Notice of Intent

Type of Action: Variance

**Procedure Description:** Mewbourne requests a variance to perform break testing and offline cementing per attached procedures for the following wells: ZACH 8 W0OB FED COM 1H APD ID# 104000088278 ZACH 8 W0PA FED COM 1H API# 3002551710 ZACH 8 W1OB FED COM 1H API# 3002551711 ZACH 8 W1PA FED COM 1H APD ID# 10400088571 ZACH 8 W2OB FED COM 1H API# 3002551714 ZACH 8 W2PA FED COM 1H API# 3002551715 ZACH 8 W2PA FED COM 2H API# 3002551716

## PECOS DISTRICT DRILLING CONDITIONS OF APPROVAL

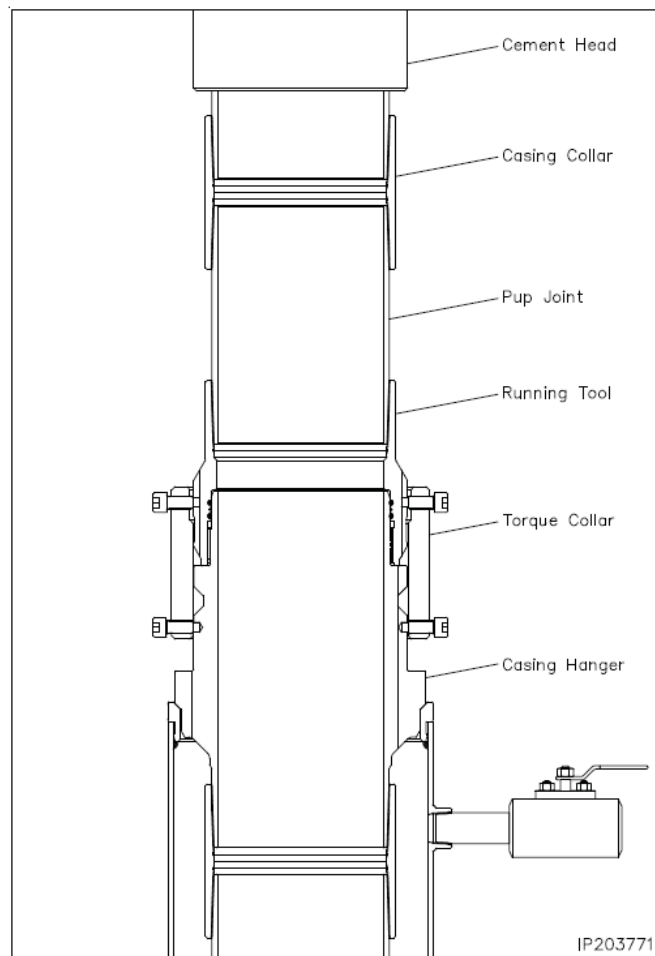
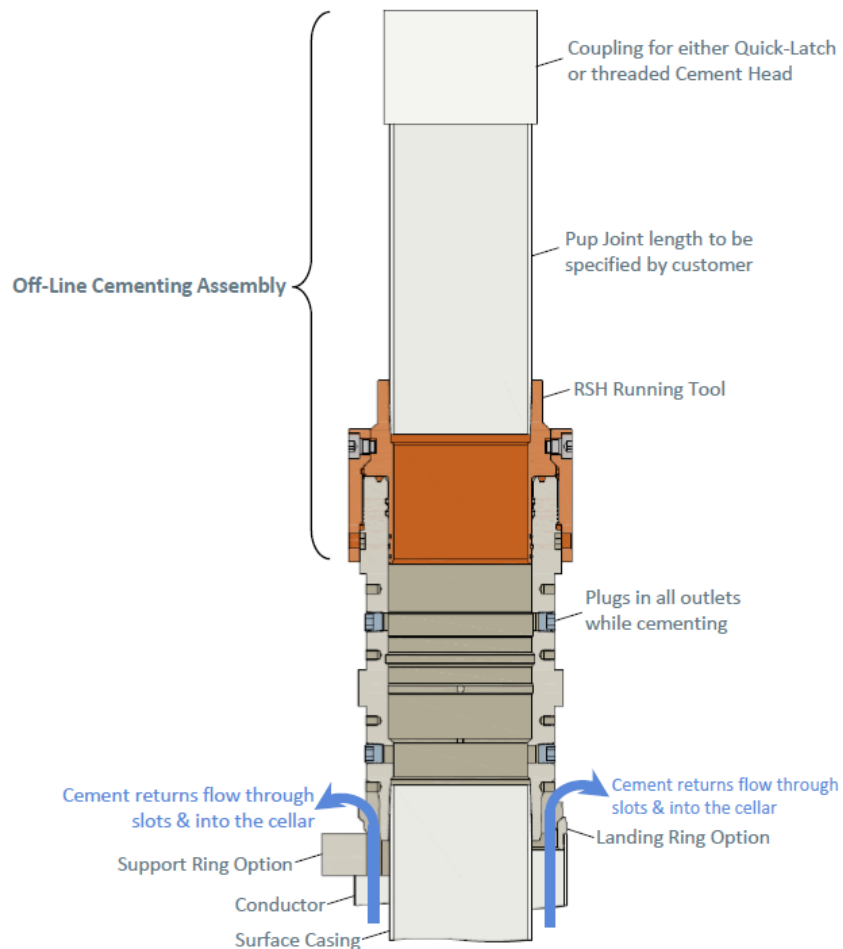
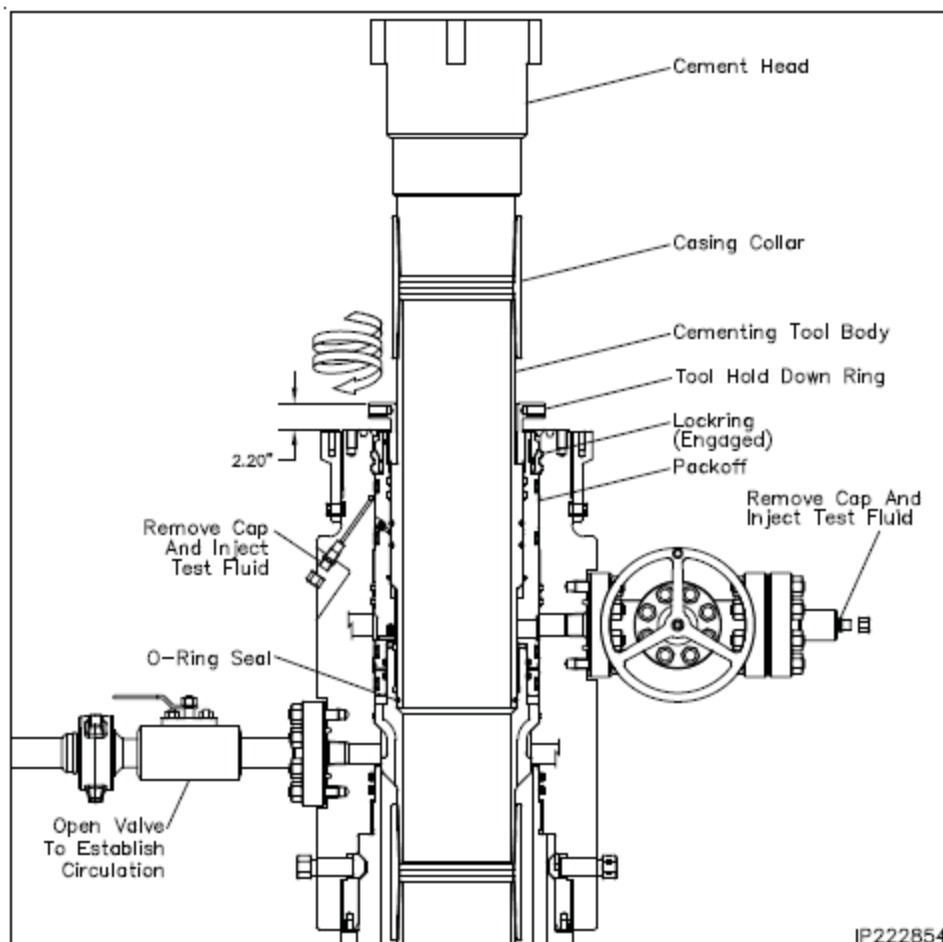
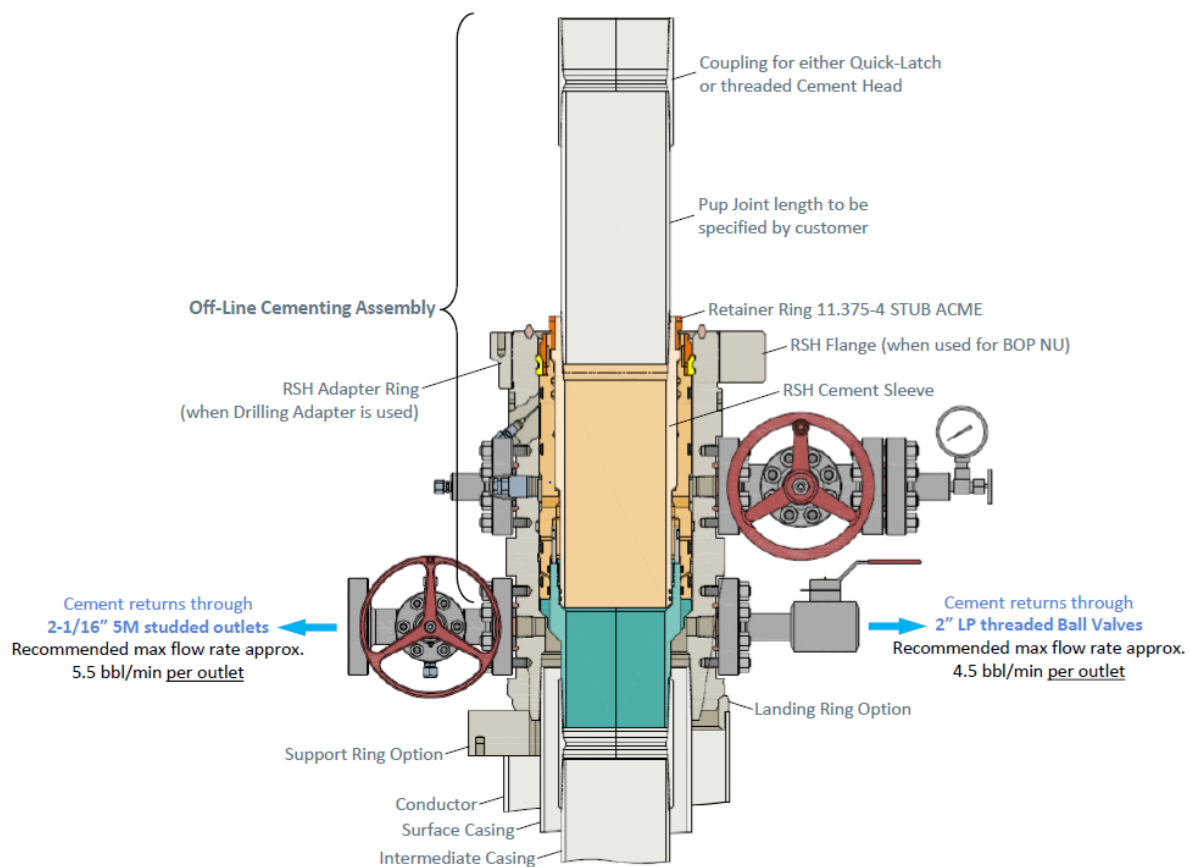
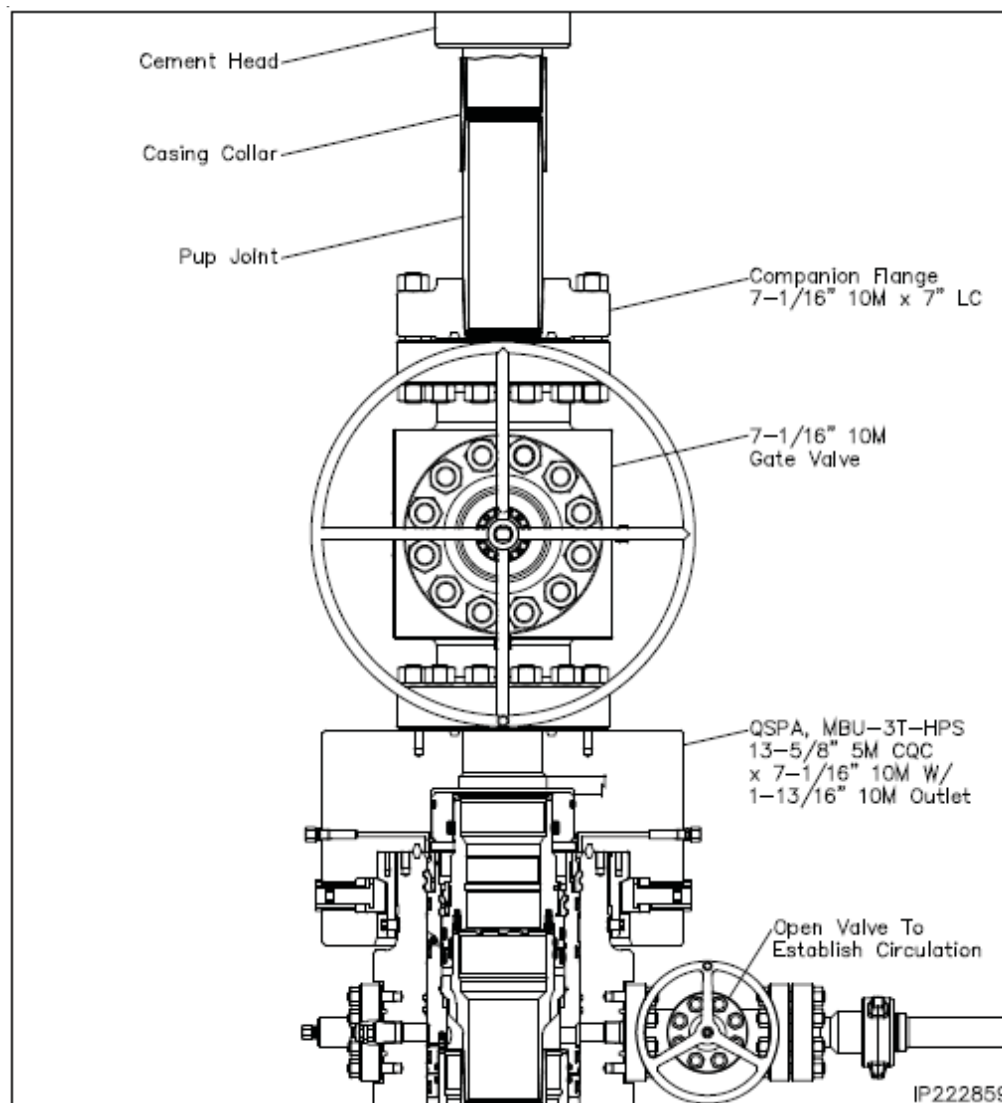
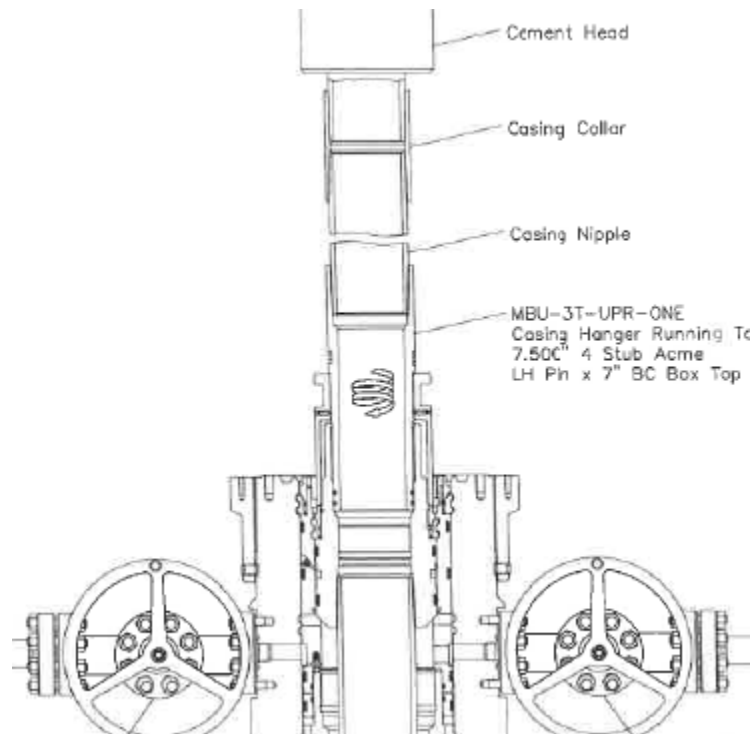
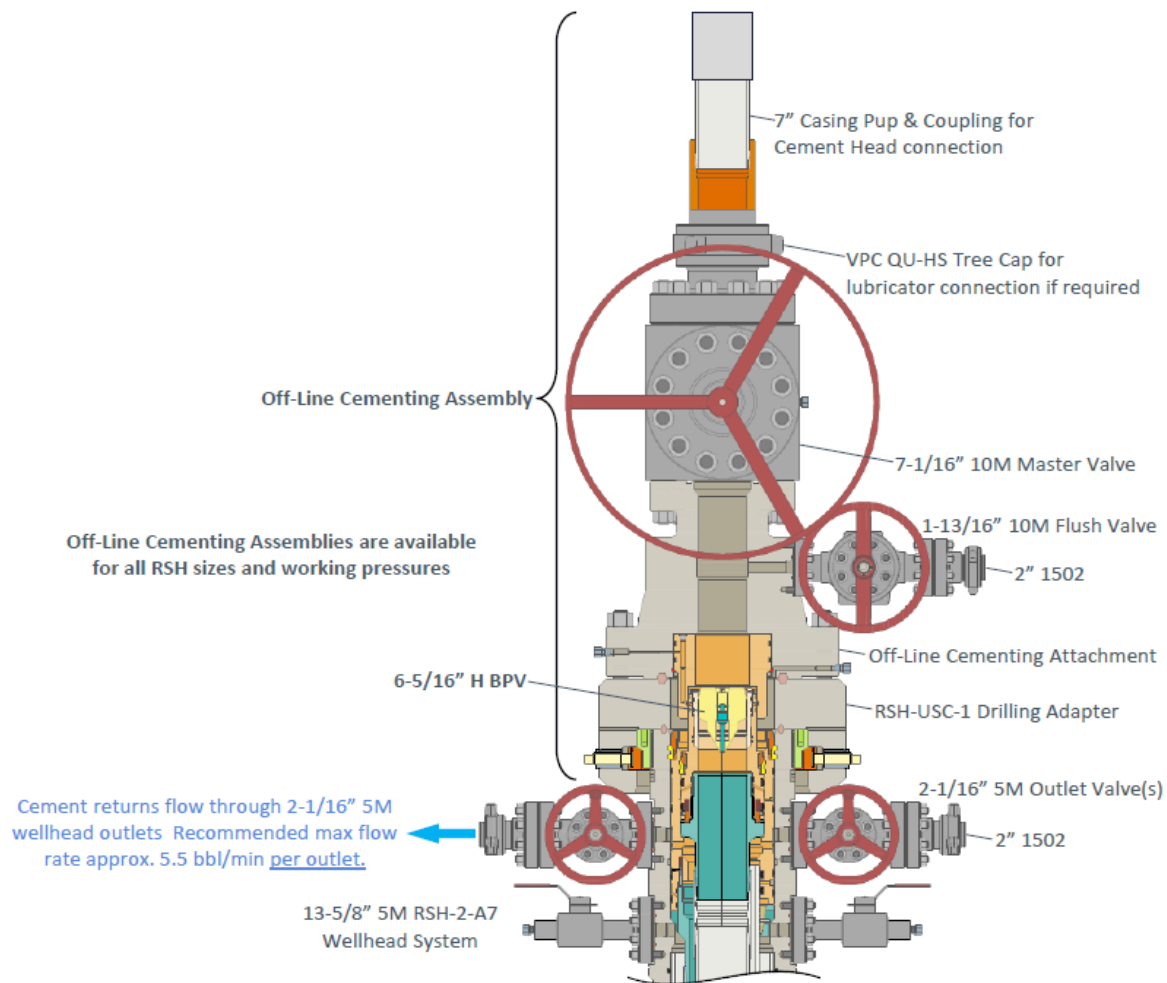
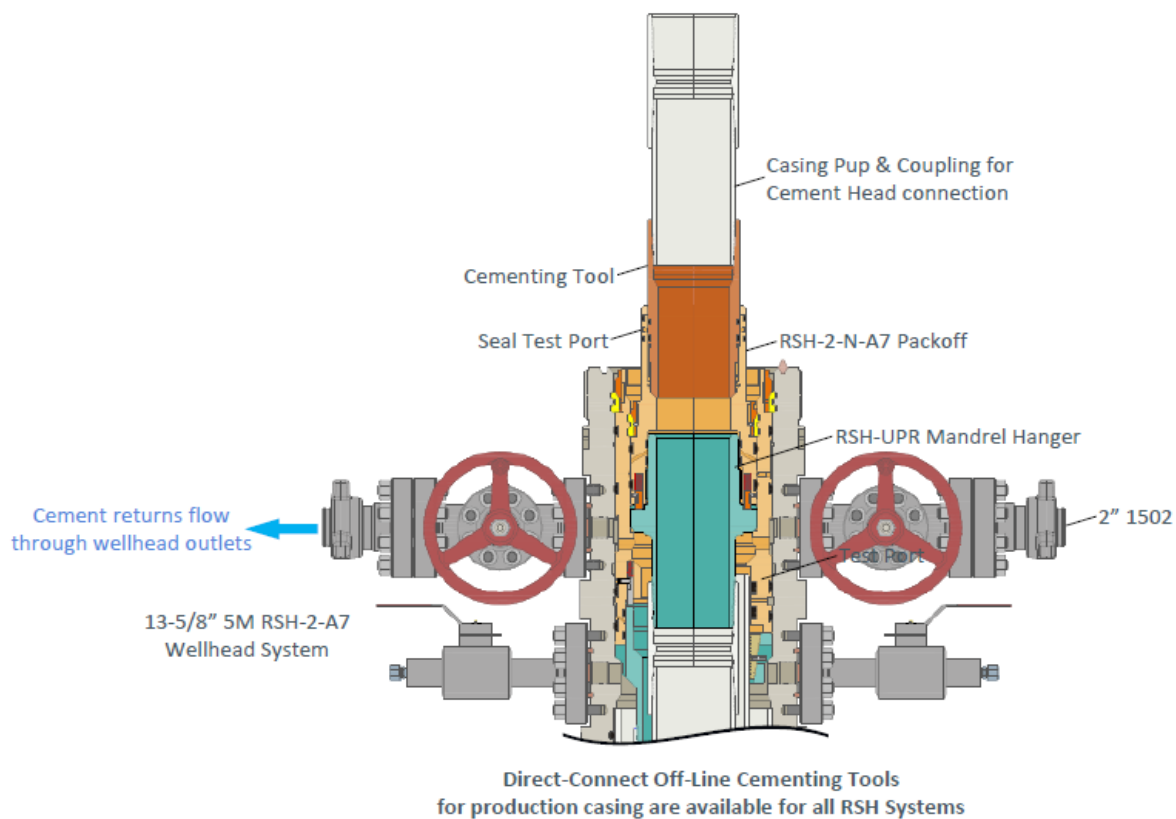
9. Make up offline cement tool with forklift per wellhead manufacturer (Fig. 1 & 2).
10. Make up cement head on top of offline cement tool with forklift.

10. Make up offline cement tool using forklift per wellhead manufacturer (Fig. 3 - 8).
11. Make up cement head on top of offline cement tool.
12. Commence cement operations.

- Operator has been (**Approved**) to pump the proposed cement program offline in the **Surface and intermediate(s) intervals**. Offline cementing should commence within 24 hours of landing the casing for the interval. Notify the BLM 4hrs prior to the commencement of any offline cementing procedure at **Lea County: 575-689-5981**.
